401 Rio Grande

City of El Paso — City Plan Commission — 3/21/19

PZDS19-00007

Detailed Site Development Plan

Detailed Site Development Plan

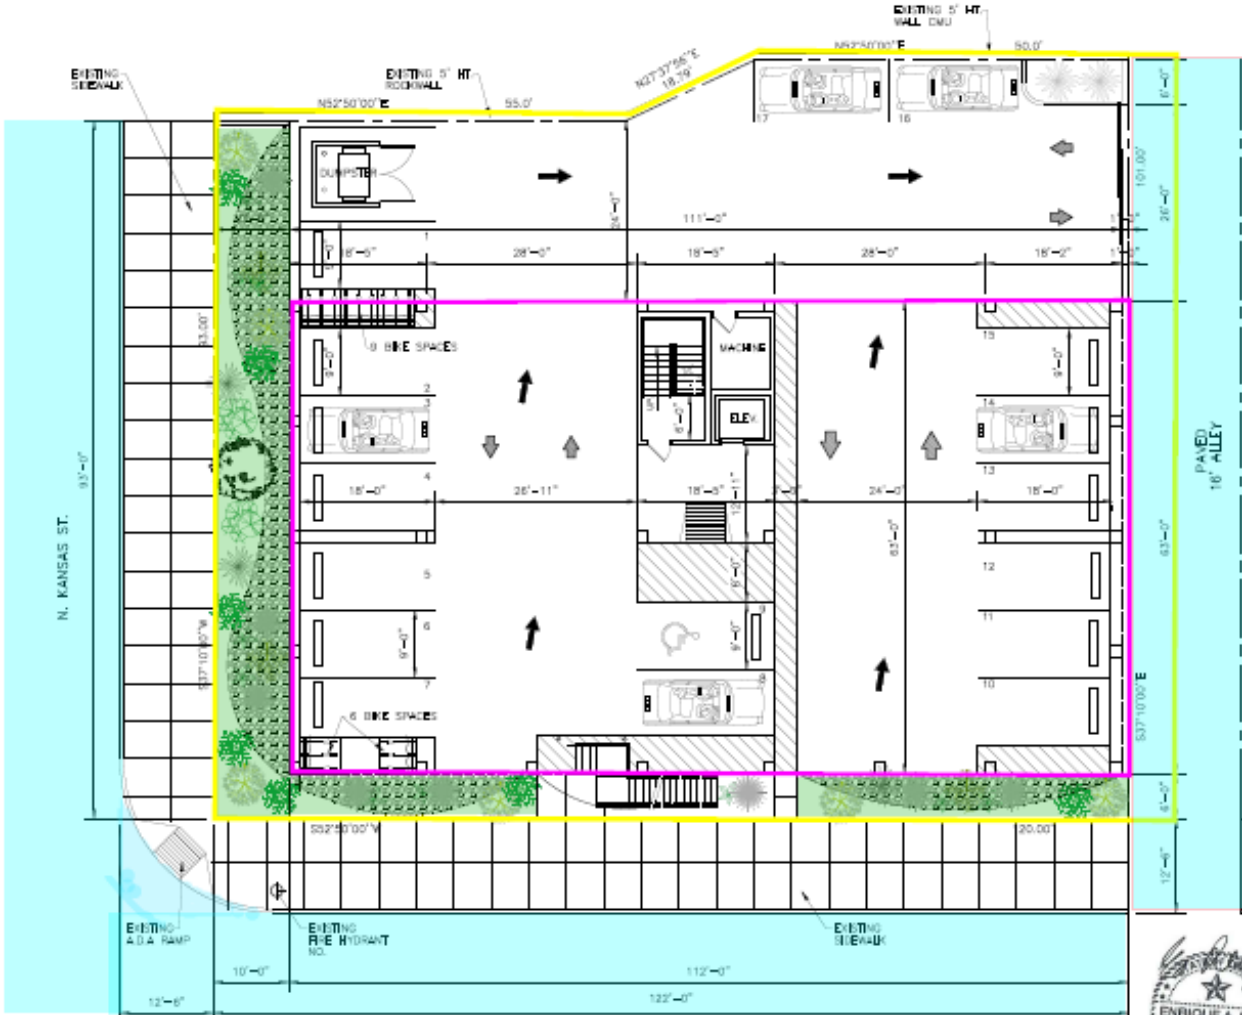
STAFF COMMENTS: The detailed site development plan will need to get reviewed and approved by City Council in order to waive the front and side setbacks from the allowed 20 feet and 10 feet to 6 feet and 1 foot. City Council will also need to review and approve the requested increase in the maximum building height from the allowed 45 feet to 47 feet 10 inches.. No reviewing departments had any negative comments. Applicant is responsible for obtaining all applicable permits and approvals prior to any construction or change in occupancy.

- This application will need to be approved by City Council in order to allow for front setback reductions from 20 feet to 6 feet, side setback reductions from 10 feet to 1 foot, and building height from 45 feet to 47 feet 10 inches.
